ADDENDUM

Addendum Number Two (02)
TO PLANS AND SPECIFICATIONS FOR
Alvin ISD Elementary School #23
STANTEC Project Nos.: 214001269

September 11, 2025

5. Comparison Between Specified and Proposed Product

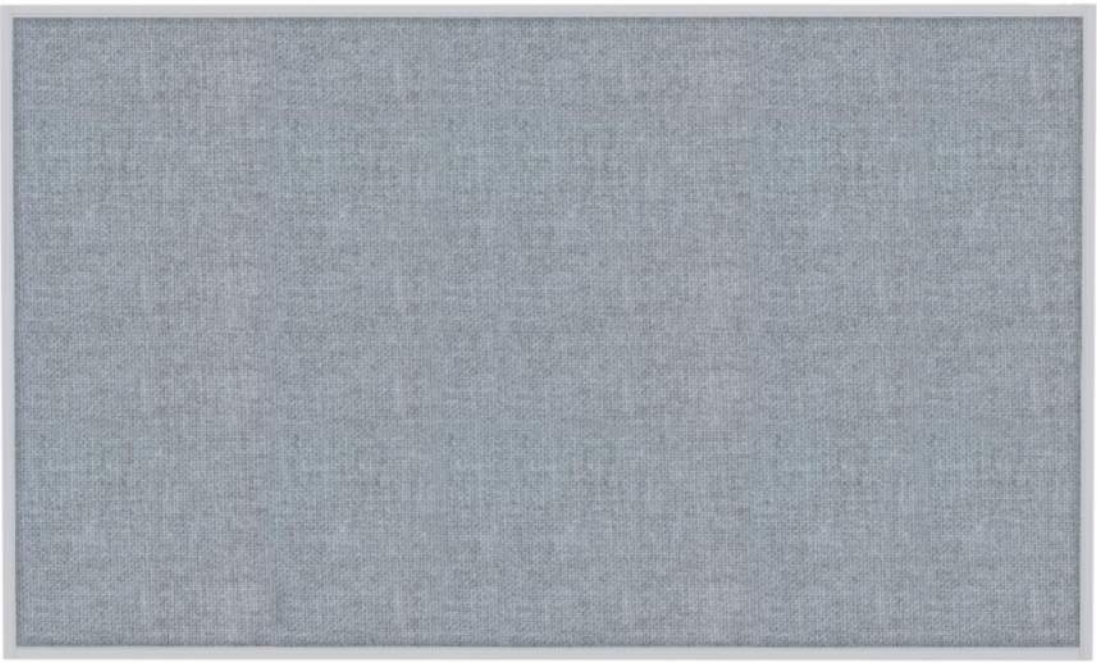
19	101100	Confirming if Nelson Adams can be added to the list of approved vendors for Visual Display Boards, see substitution request.	There is no "Display Case" in the job. There is open shelving for display but it is by the casework sub.	2
20	101100	Please provide spec for display case shown on A821/C1. Confirming if Nelson Adams will be a approved vendor, see substitution request.	If approved it will be in Addendum #2	2
21	101100	Confirming if Nelson Adams can be added to the list of approved vendors for Sliding Marker/Tack Boards, see substitution request.	Tackboards are fixed, not sliding like at the previous school. If approved this TB manufacturer will be in Addendum #2	2
22	107326	Confirming if Canopy Solutions can be added to the list of approved vendors for Canopies, see substitution request.	They were alread added in Addendum #1	-
23	P102	Please size storm line at the northeast corner of area B. Appears updated on P002.	See updated P002	2

1. Section 10 11 00, for Visual Display Surfaces;
    a. Add approved manfacturer **Nelson Adams NACO.**

Landscape Plan L001:

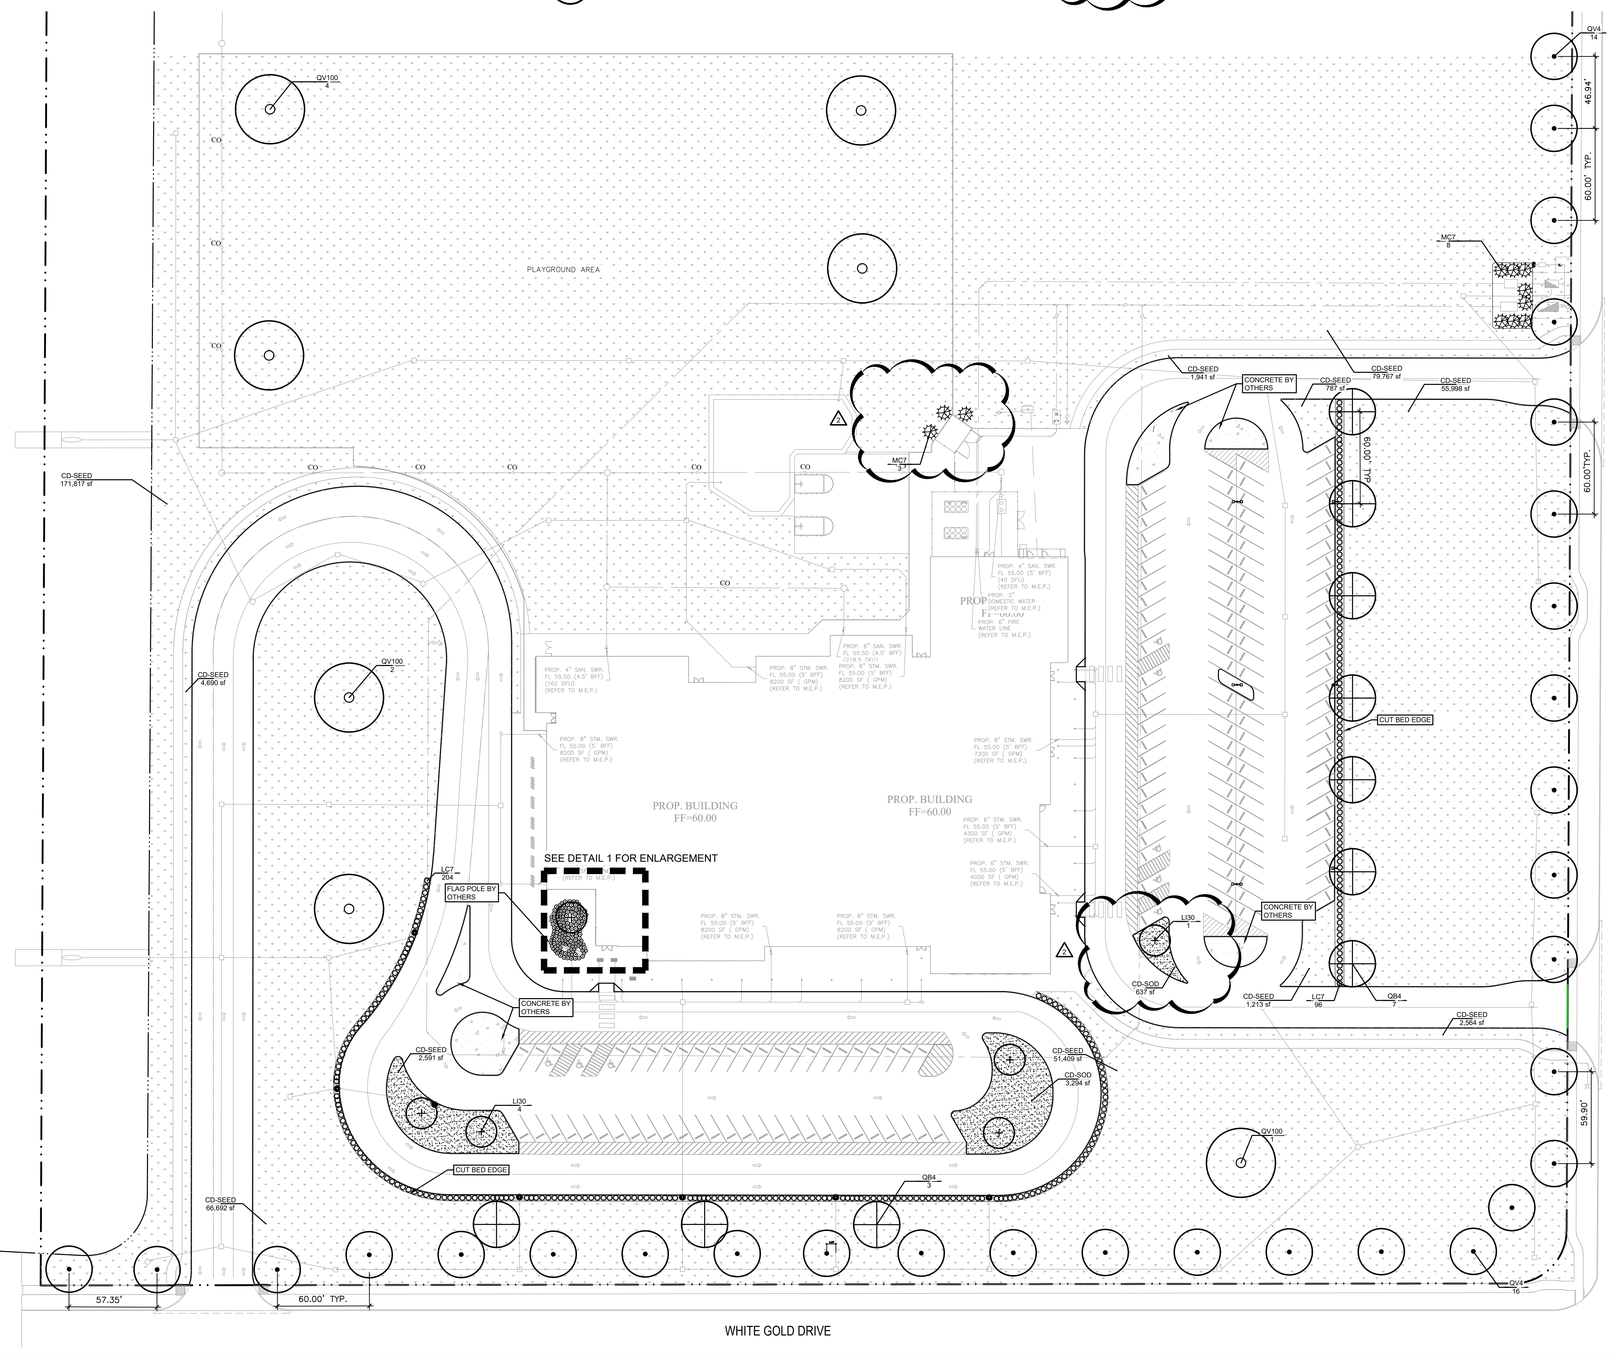
- The number of screening shrubs around the Dumpster area has been reduced to three.
- The planting bed for these screening shrubs has been removed.
- One parking island has been updated to sod instead of seed.

Irrigation Plan L003:

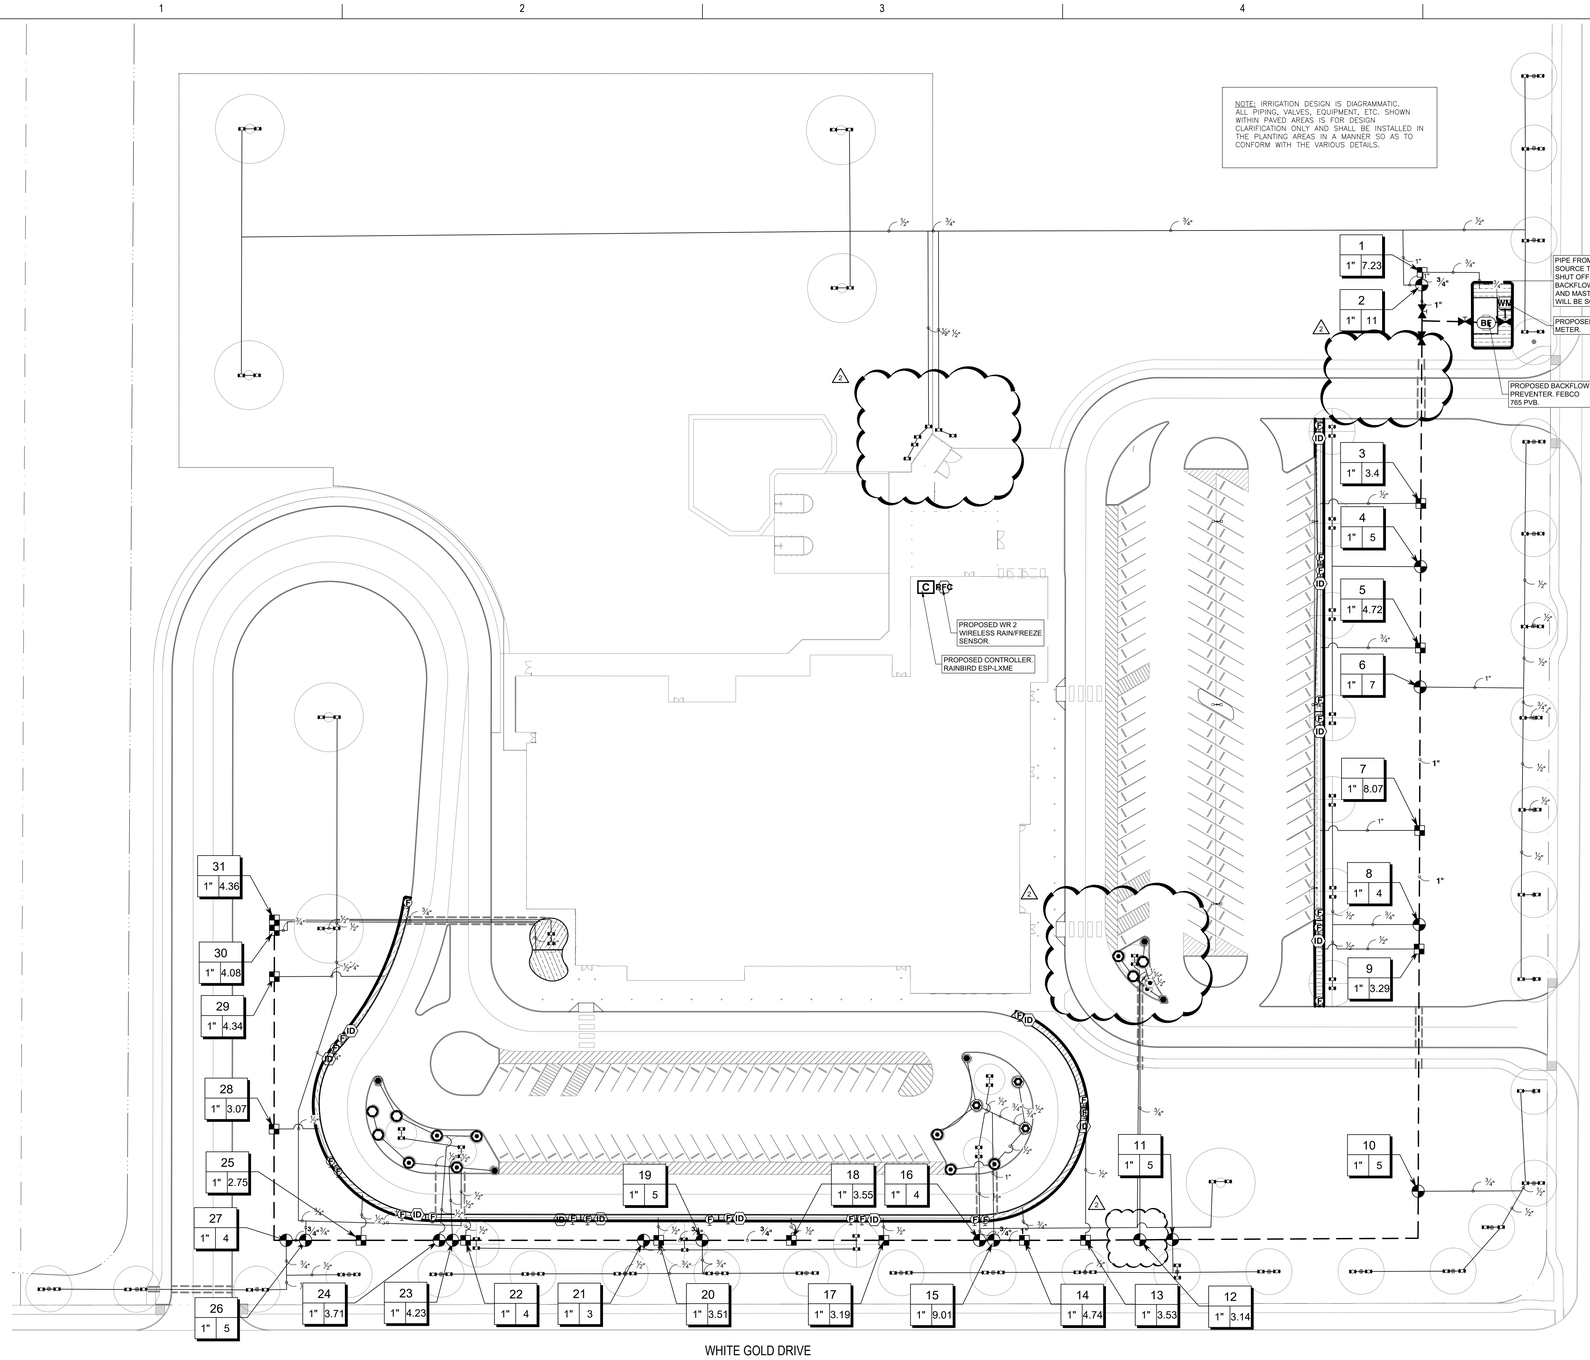
- The original drip irrigation system for the screening shrubs around the dumpster area has been replaced with tree bubblers.
- Turf spray heads and one valve have been added to the sod area in the parking island.
- Tree gator bag in the parking island has been replaced with tree bubblers.

C1 A202 **ENLARGED EAST EXTERIOR PARTIAL ELEVATION 1**
1/8" = 1'-0"

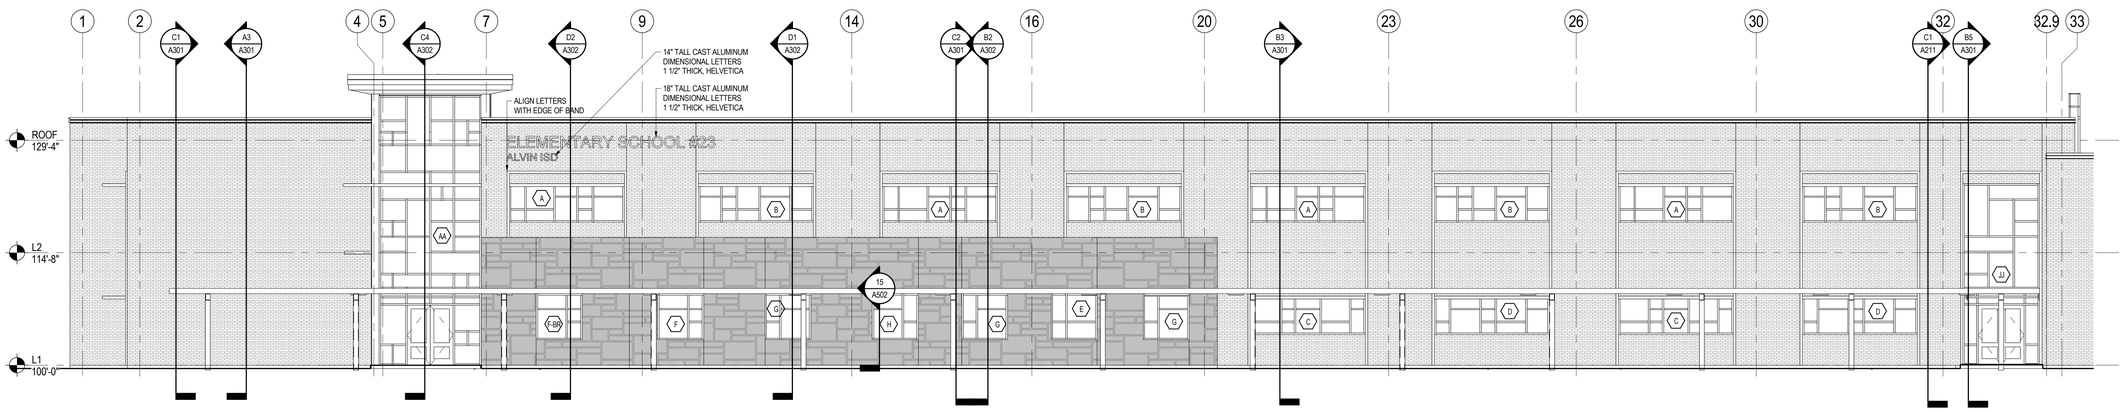
15	Misc. Pads	Will select fill be required under the chiller and generator pad and will it follow the building slab requirements or pavement requirements.	Refer to the geotech report and supplementary letter from Terracon that is in the specification. Contact Terracon for specific questions.	2
16	A501	Sheet A501 is missing the sign types to be associated with each door. Please provide updated schedule.	A501 updated	2
17	A201	Please re-issue A201 of Add. #1. Page is corrupted.	Included in ADD#2. Additional finish information provided on sheet.	2
18	A111/A202	There is a callout (D1/A202) for the extruded brick pattern at the intersection of gridlines AD and 4 on page A111. Elevation A1 on page A202 does not show the extruded brick pattern on that section of wall called out on page A111. Please advise if brick pattern is included at that location	Refer to sheet A202, details D1, D2. The pattern is illustrated.	2
